HYDROGEOLOGY OF SPRING, CAVE, DRY LAKE, AND DELAMAR VALLEYS

**IMPACTS OF DEVELOPING SOUTHERN NEVADA WATER AUTHORITY'S CLARK, LINCOLN, AND
WHITE PINE COUNTIES GROUNDWATER DEVELOPMENT PROJECT**

Presented to the Office of the Nevada State Engineer

on behalf of Protestants White Pine County, Great Basin Water Network, et al.

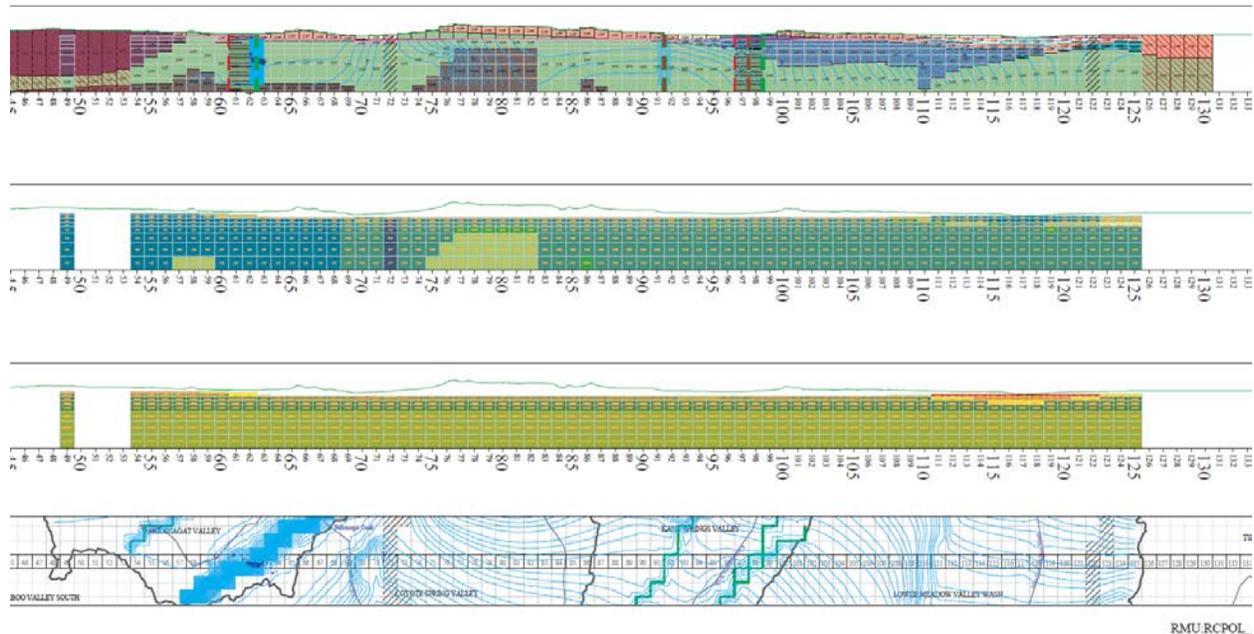
Conductivity in the seven layers in the conduit shown in Coyote Spring Valley from layers 1 through 7 is 0.0278, 22.1, 61.4, 51.8, 40.2, 27.7, and 17.7 ft/d (Figure 39). Figure 39 does not specify layer thickness but the bottom is at -10,000 feet and the upper layer is at about 2000 feet; the upper layer with low conductivity is very thin. The average conductivity of the lower six layers is 36.8 ft/d, not weighted for layer thickness because the thicknesses are not provided. Gradient across a cell is quite variable, but the contours suggest about 20 feet over 3280 feet, or about 0.0061 ft/ft. Applying Darcy’s law, the flow through just one north-south column of cells would be about 67,900 af/y. There would be flow exchange between the high K and surrounding lower K cells due to the surface not being perfectly flat. Figure 39 shows groundwater contours, in the upper cross-section showing conductivity by model cell and in the lower plan view, that converge on the high conductivity flow path that represents a fault zone.

The specific storage values for the carbonate rock specified in the conceptual model report (SNWA 2009a) averaged $8.26 \times 10^{-6} \text{ ft}^{-1}$ with a maximum and minimum value equal to 1.24×10^{-5} and $4.67 \times 10^{-7} \text{ ft}^{-1}$. The calibrated values used for the numerical model for carbonate rock near Coyote Spring were 1.95×10^{-4} , 1.35×10^{-4} , 9×10^{-5} or $6 \times 10^{-5} \text{ ft}^{-1}$ (Figure 39). Thus, the calibrated

Figure 40: Snapshot of a portion of Figure 3 (SNWA 2009c) showing the zone between Spring Valley and Big Springs to be characterized by the monitoring plan.

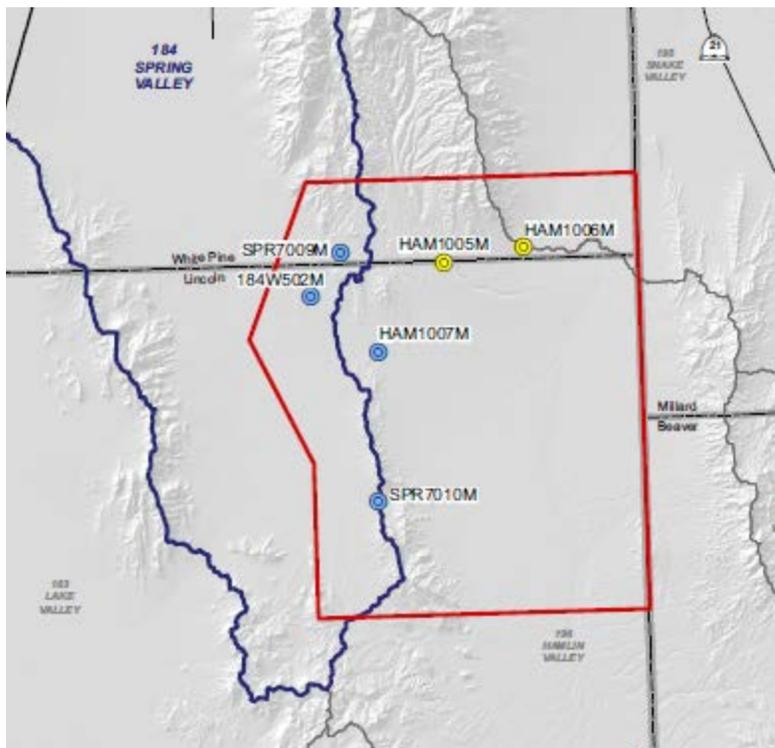
Valley, Hamlin Valley, and Snake Valley near Big Springs. This approach would not be effective because the wells would be so spread out, both spatially and among aquifers, as to estimate just one gradient over an area ranging about 12 miles east-west and 18 miles north-south (Figure 40). The bedrock geology is primarily carbonate rock with interspersed volcanic rock and with various faults. The bedrock is highly heterogenous so monitor wells that span multiple flow paths would at best provide a single, cursory estimate of gradient.

Figure 42: Portion of model row 126 near the east side of the Snake Range near Baker. White lines are cells, blue lines are groundwater head contours. Other colors represent hydrogeologic units as labeled.

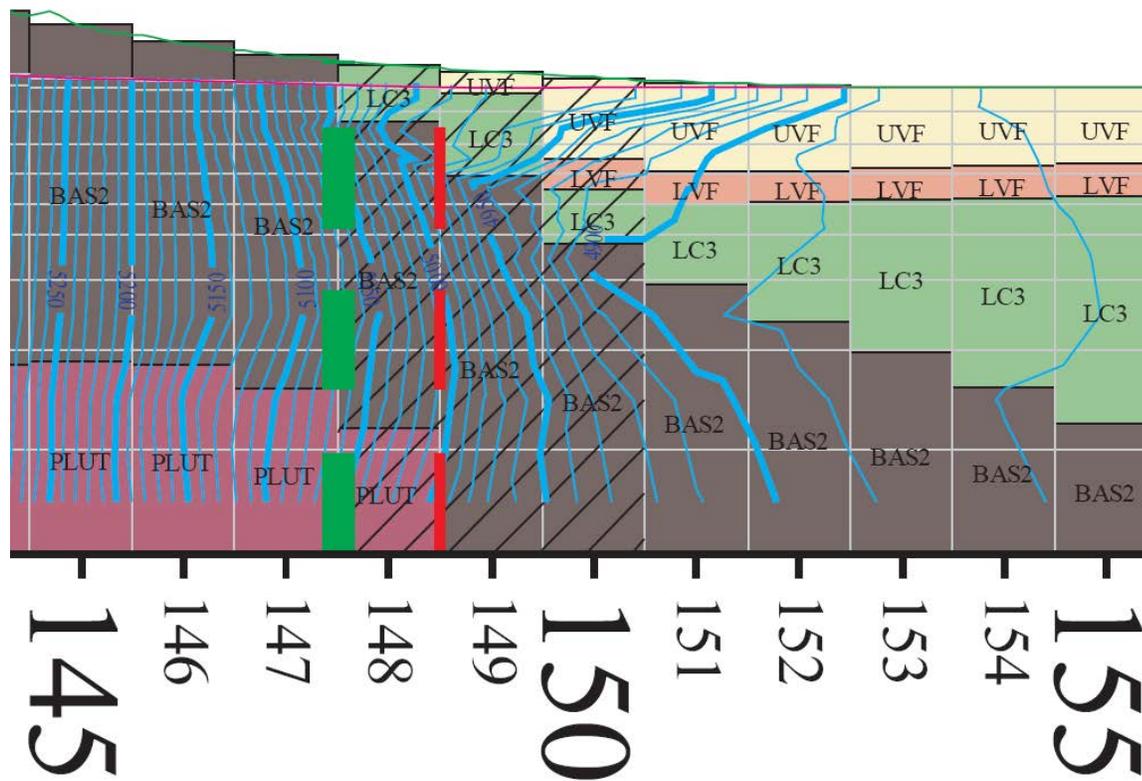
The east front of the Snake Range, near Baker, is a great example of the inappropriate averaging of formations in one cell by SNWA's model. As may be seen in Figure 42, in column 149, the model averages UVF and LC3 properties. In column 150, the model averages LVF and LC3 properties. Considering the conductivity values by cell, the model combined values that differ by more than an order of magnitude (Figure 43). Also, the model would not allow continuous flow along the LC3 unit under Snake Valley because the unit does not match in

adjacent cells (Figure 42). This forces the groundwater to follow unrealistic pathways. It would essentially force water in the LC3 unit in column 149 to flow into the LVF unit in column 150.

Figure 44: Portion of NMR Figure 6-9 showing the unweighted residual for the northern two-thirds of the model domain.

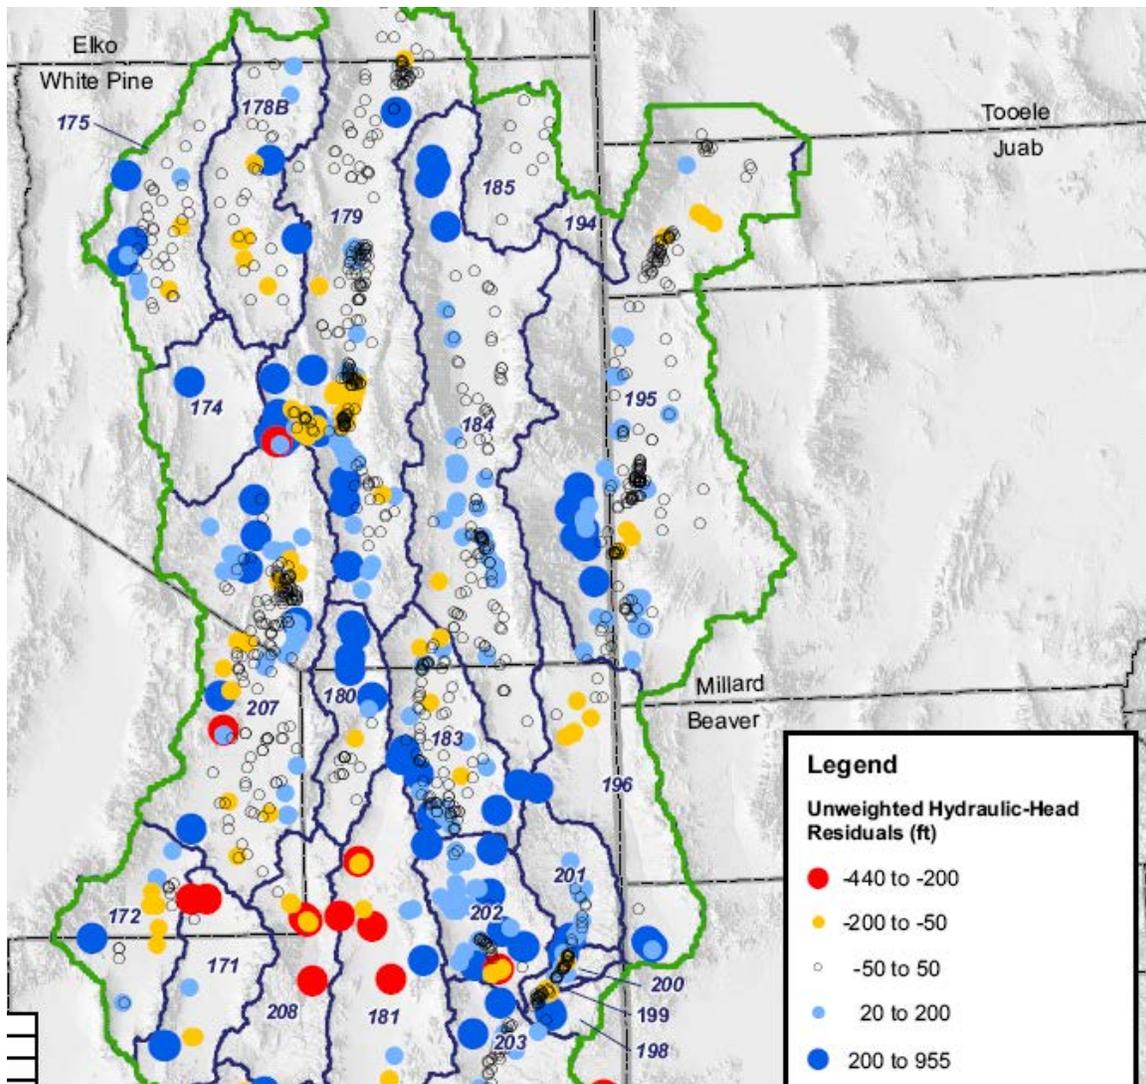
The initial conditions were set at the steady state solution which is appropriate especially since, as evidenced by the residuals (Figure 44), the simulated steady state head varies significantly from the observed values. SNWA adjusted the storage coefficients to attempt to calibrate these values because the coefficients control the rate that the model releases groundwater from storage. Drawdown residuals are much less than steady state values (Figure 45) because the actual drawdowns due to existing development are relatively small; sixty years of drawdown was about 5 feet and up to 25 feet in Spring and Snake Valleys, respectively. SNWA claims that:

Figure 45: Portion of NMR Figure 6-10 showing the unweighted drawdown residuals. These values are from the transient calibration.

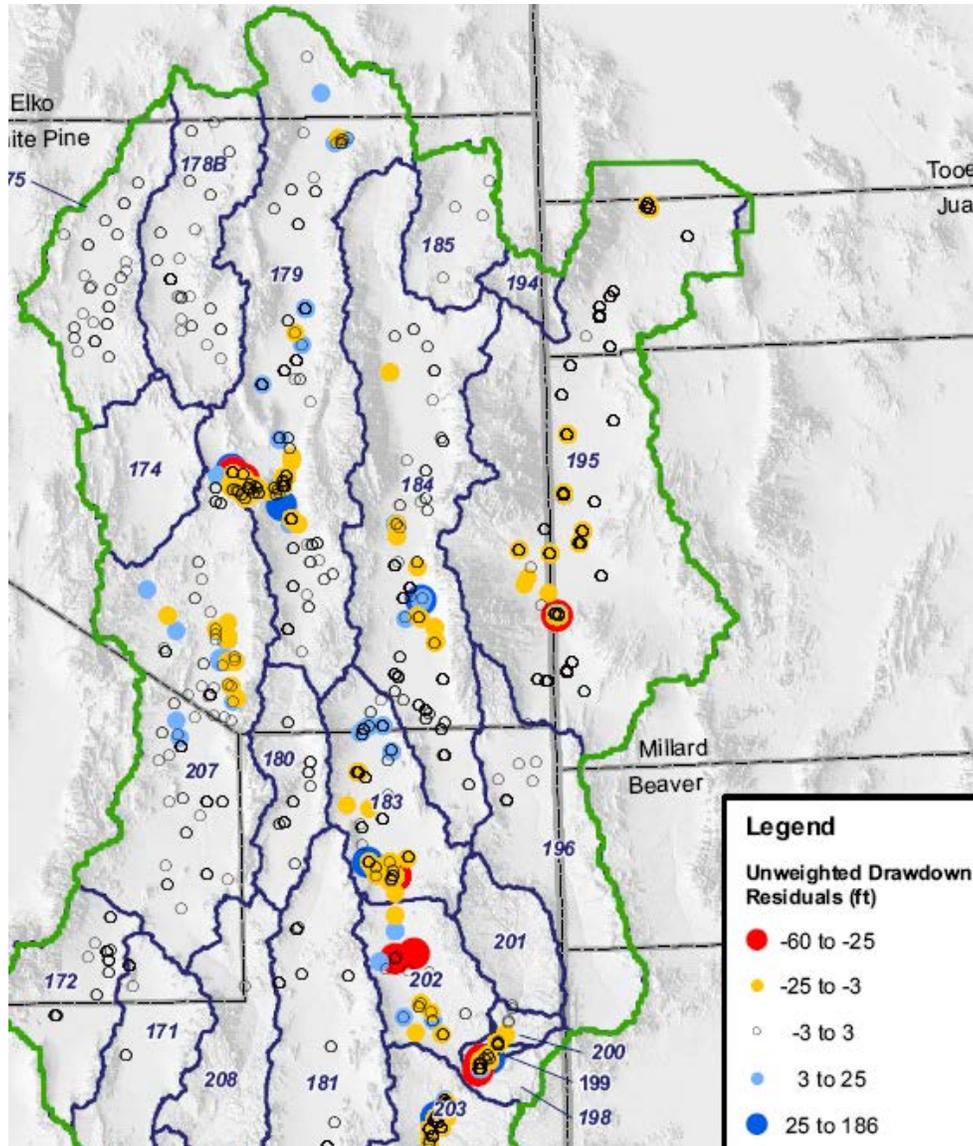
The distribution of residuals shows clearly that the water levels are underestimated in Snake Valley, Lake Valley, Spring Valley, and the north and south ends of Steptoe Valley (there is a prevalence of blue markers (Figure 45)). Large residuals appear in the mountain blocks which reflect the significant topographic gradients there. The cause for this is unclear, but could be due to the lower weights given to mountain block observations. Wherever the residuals are positive, as in the listed basins, the model clearly underestimates the flow gradient between the valley and mountain block which would bias the conductance between the mountain and valley to higher values, meaning the transmissivity could be too high. **This would allow the pumping to draw water from mountain block with less drawdown more quickly, a clear bias to underpredicting drawdown near the mountain front.**

Figure 46: Figures 6-3 and 6-4 from the NMR report showing two Snake Valley wells.

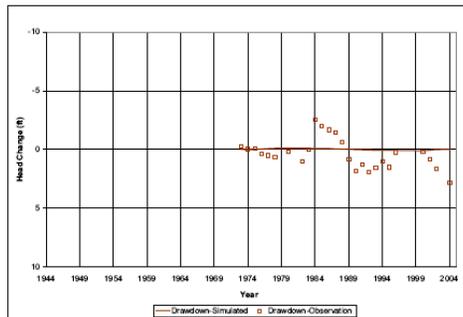
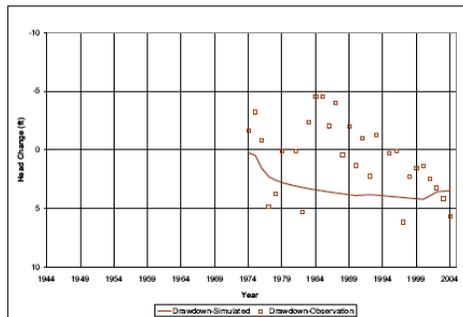
The statement regarding Snake Valley is not correct, as shown on Figure 46. The well in NMR Figure 6-3 fluctuated plus or minus 3 feet and the model simulated no changes; the well in NMR Figure 6-4 fluctuated plus or minus 5 feet while the model simulated a 4-foot drawdown (Figure 46). Failure to consider seasonal and annual recharge variations likely caused the observed changes, thus the model is only considering a partial representation of the stresses. The calibrated storage coefficients could be substantially wrong because they are based on an

implicit assumption that pumping causes all drawdown. The simulated flat drawdown on NMR Figure 6-3 could be caused by a fault or other effective barrier preventing communication between the pumping and observation wells in the model. If a modeled barrier limits the propagation of stress inappropriately, the model is likely to underestimate impacts in portions of the valley - Snake Valley in this example but this type of problem would likely occur elsewhere.

Figure 47: Figures 6-7 and 6-8 from the NMR report.

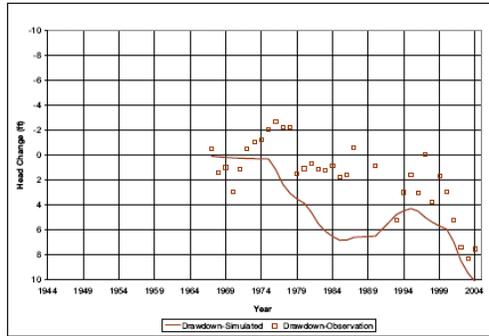
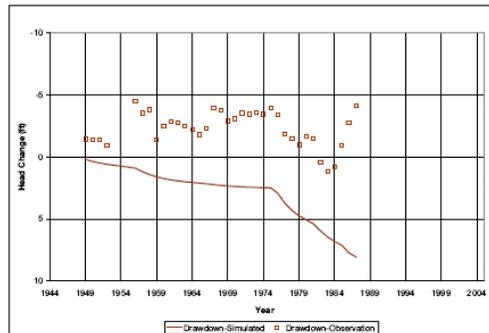
NMR Figures 6-7 and 6-8 show a different response in different wells in the same cell (Figure 47). The NMR should discuss whether the wells are developed in different formations, noting that as discussed above, a cell may agglomerate several formations. These figures illustrate a potential error caused by combining formations in one layer or cell and indicates that the layer thickness for the uppermost model layers may be too thick.

Figure 48: Snapshot for Row 100 showing groundwater contours and hydrogeologic formations near Gandy Warm Springs, near column 148.

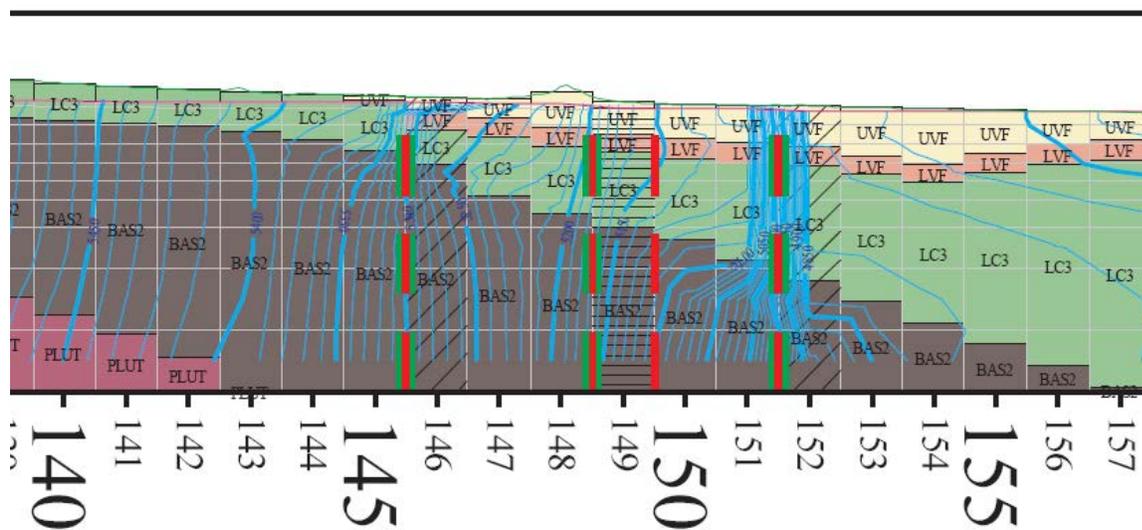
SNWA discounts the likelihood that interbasin flow from Spring Valley could support the spring (NMR, page 5-6). This is curious because the model simulates 11,800 af/y of interbasin flow to Snake Valley just to the north of Gandy Warm Springs, which is of the same order of magnitude as the approximately 16,000 af/y estimated for this region in BARCASS (Welch et al, 2008, Figure 41). While there is uncertainty and disagreement around the BARCASS estimate, the model simulation shows it is credible. If even a third of that amount combined with carbonate recharge in the northeast portion of the Snake Range, the Gandy Warm Springs flow could be accurately reproduced.
